From: Langdon, Robert <RLangdon@scsengineers.com>
Sent: Friday, September 17, 2021 4:45 PM
To: Vitale, Matthew J - DNR
Cc: Garth Frable
Subject: RE: Site Investigation Workplan Notice to Proceed - Blackhawk Junction BRRTS #s 02-12-552357, 06-12-587767
Attachments: Proposed Sewer Sample Locations.pdf

From: Vitale, Matthew J - DNR <Matthew.Vitale@wisconsin.gov>
Sent: Wednesday, July 28, 2021 10:59 AM
To: Langdon, Robert <RLangdon@scsengineers.com>
Cc: Garth Frable <gfrable@prairieduchien-wi.gov>
Subject: Site Investigation Workplan Notice to Proceed - Blackhawk Junction BRRS #s 02-12-552357, 06-12-587767

FORMER BLACKHAWK DRYCLEANERS

PROPOSED SEWER AIR SAMPLE LOCATIONS

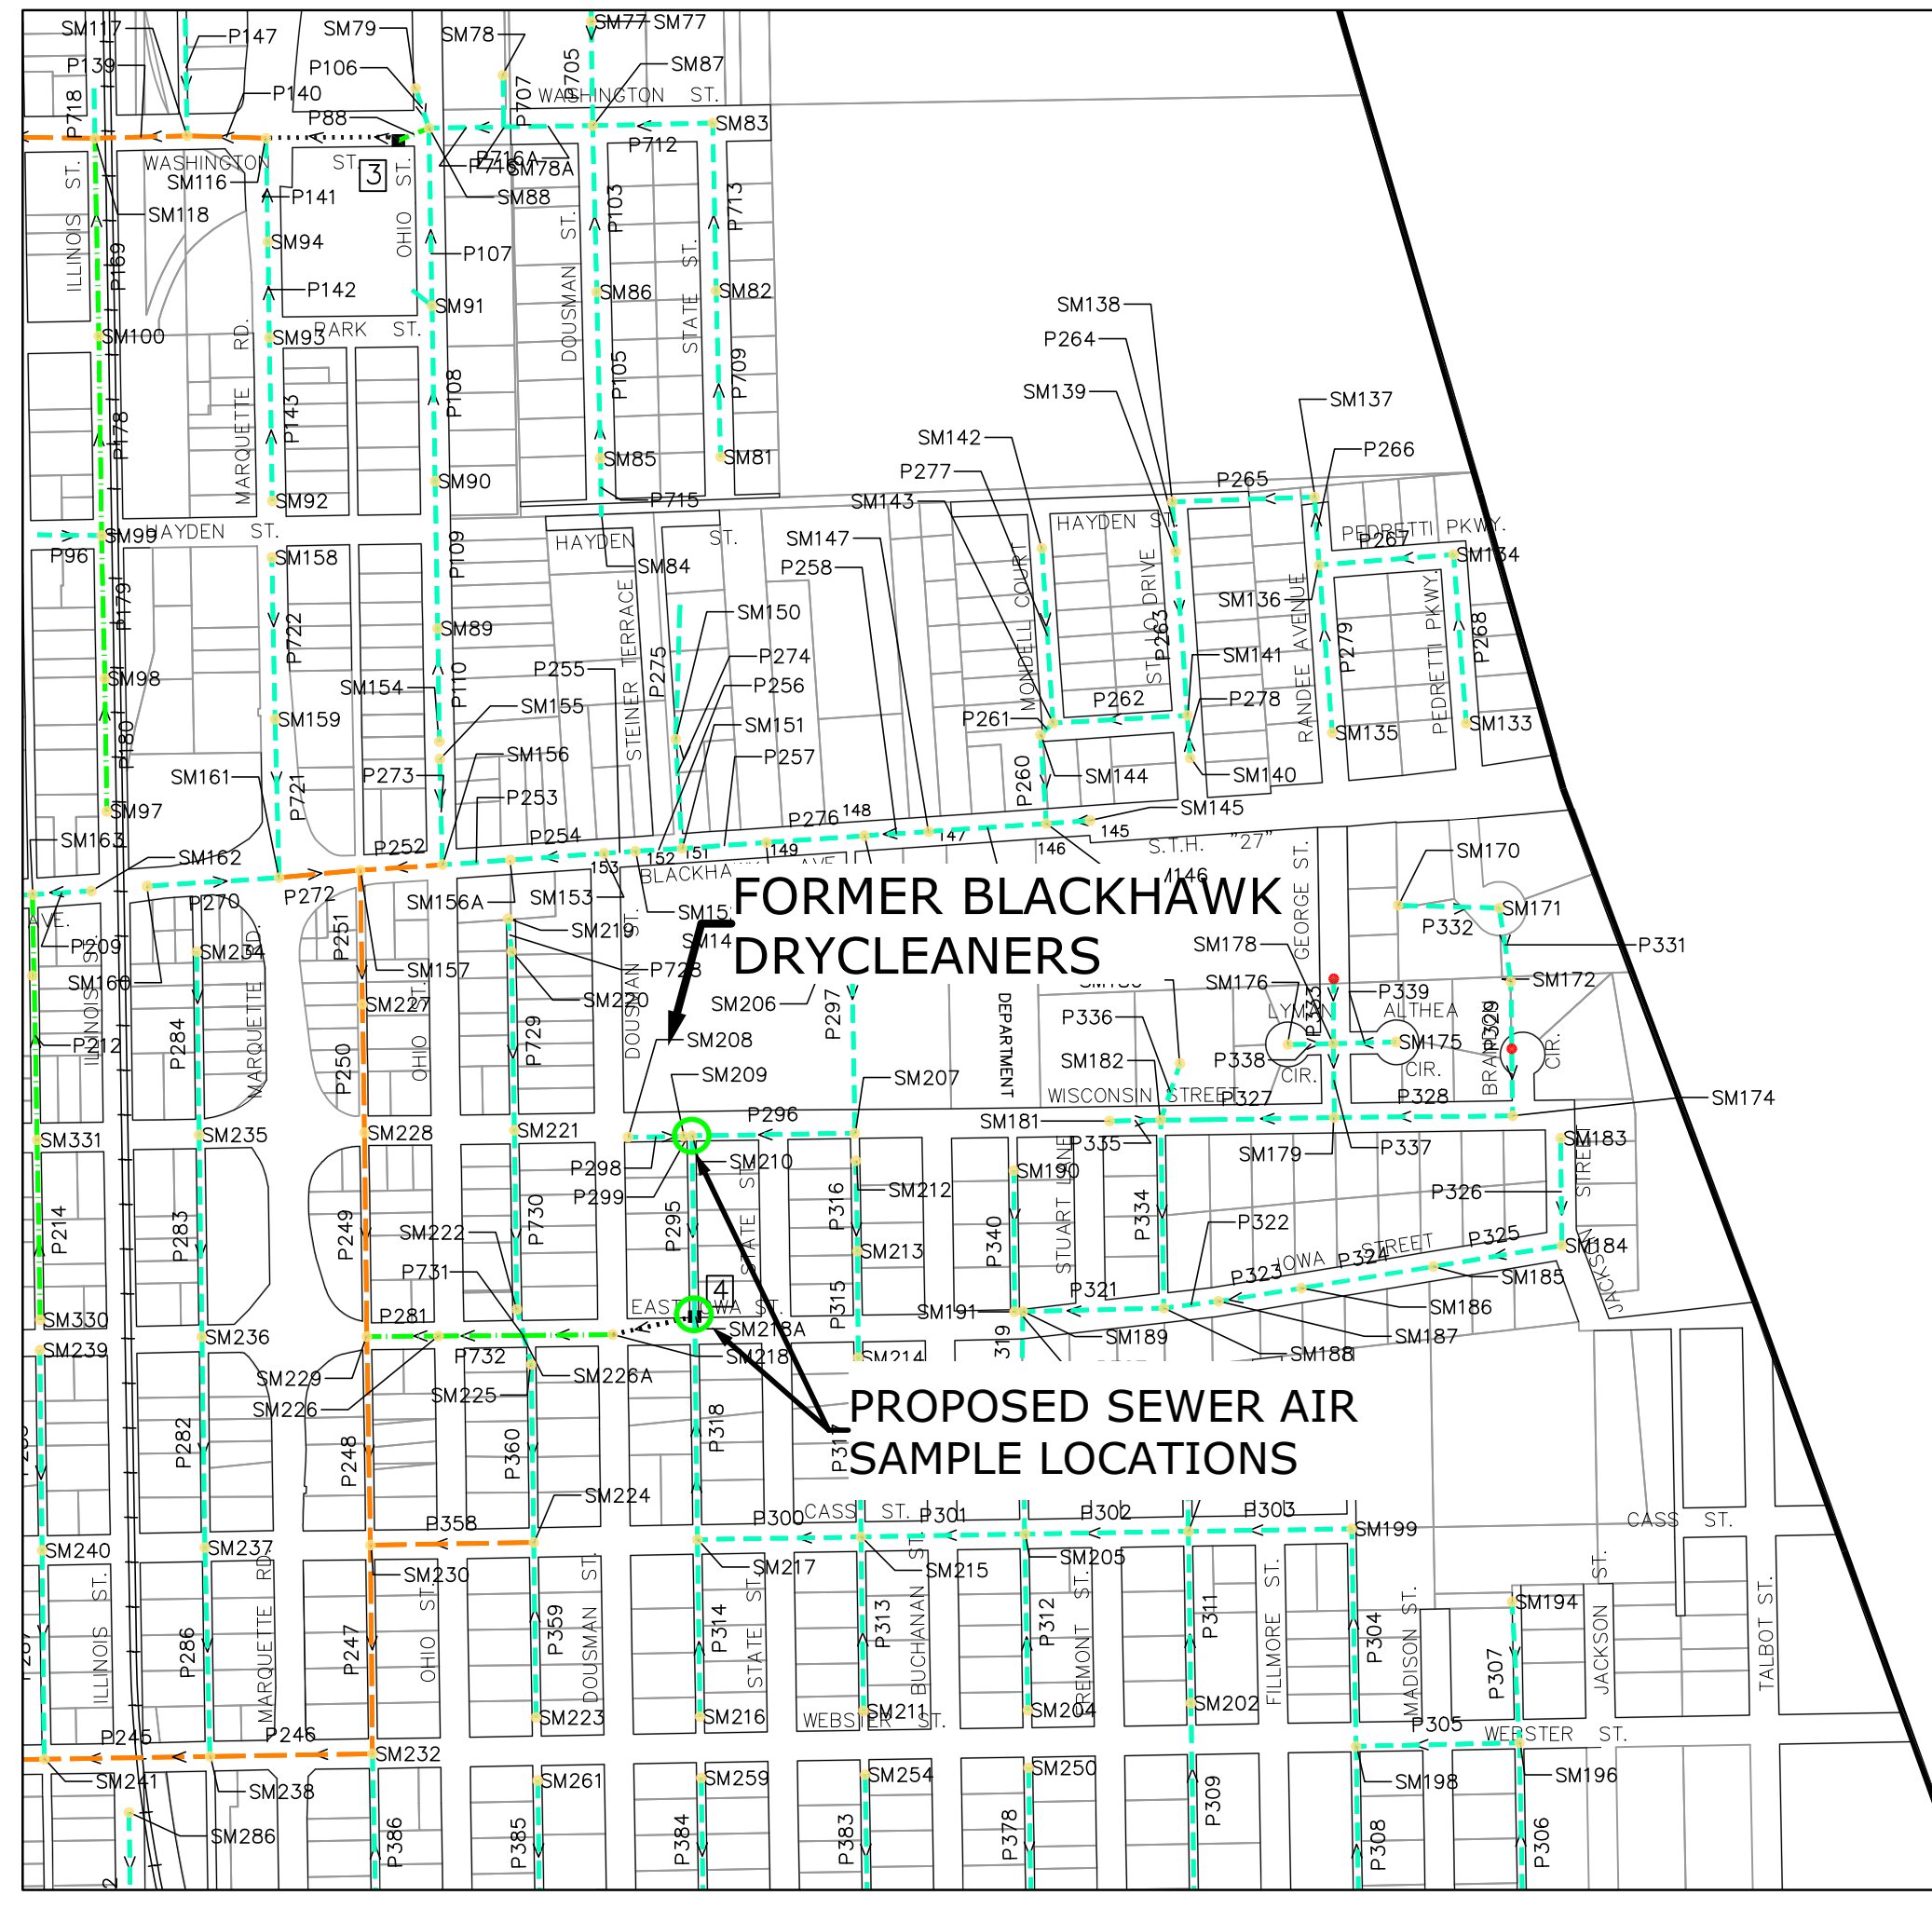
Matt, as discussed by phone earlier this week, we propose to evaluate the sanitary sewer between South Dousman Street and State Street as a potential preferential pathway for migration of chlorinated volatile organic compounds from the former Blackhawk Drycleaners. Proposed sample locations are shown on the attached map. Our proposed scope is summarized below:

- Collect sewer vapor samples from sanitary sewer manhole SM210 and sanitary sewer lift station manhole 4. The sampling will be performed consistent with WDNR guidance document RR-649 dated June 2021.

1. Evaluation of emerging contaminants – all open sites were sent a letter in August 2020 that explained the requirement for evaluating emerging contaminants as part of the site investigation workplan. [The letter](#), along with our [Site investigation Scoping guidance document](#) goes into additional detail.
2. Investigating human-made preferential pathways – [A new guidance document](#) for this was published in by the department in June, and discusses the considerations and sampling methods. This is important here, because from the 1991 Soil Gas survey (see attached), there was elevated PCE to the south of the former dry cleaner between S. Dousman St and S. State St (location 32). Based on your figures, there is a sewer line that runs between the houses on that street, which may be acting as a preferential pathway.
